**RE: RESOURCE CONSENT APPLICATION 101.2025.119.1 & 102.2025.119.1
YEDO INVESTMENTS LIMITED, 44 GRESHAM STREET, GERALDINE
RESPONSE TO FURTHER INFORMATION REQUEST**

This letter responds to your further information request dated 16 October 2025. It provides each item of your further information request in bold italics below and then provides the applicant's response to that item.

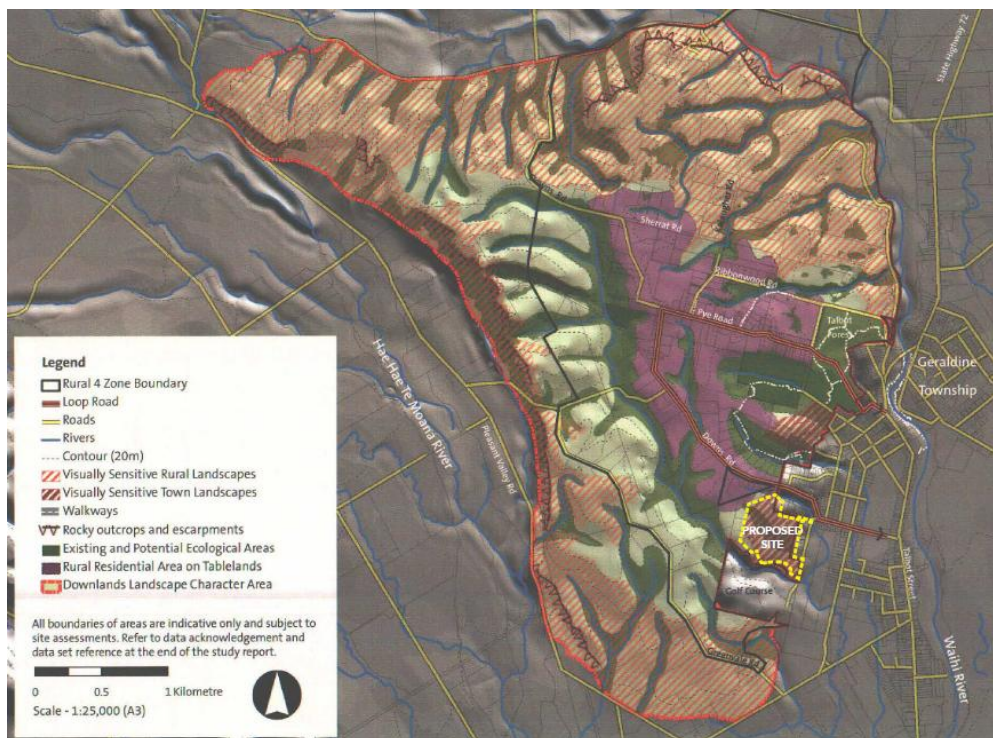
- 5. *What are the cumulative effects of domestication on the Geraldine Downs Visually Sensitive Town Landscape?***

“The Visually Sensitive Town Landscapes is shown in the Geraldine Downs Landscape Study prepared by Boffa Miskell in July 2008. We note that it does not form part of the Operative District Plan. For reference, it is shown in Section 8 of our Graphic Supplement, with a copy included below:

Due to the close similarity of the red hatches used, section 8.1 of the LVA, incorrectly identified the site as being in the ‘Visually Sensitive Rural Landscape’. The site is instead part of the ‘Visually Sensitive Town Landscape’. The development proposed looks like it would occupy approximately half of this area, which is on the flanks of the hillside. The assessment conclusions made still stands”.
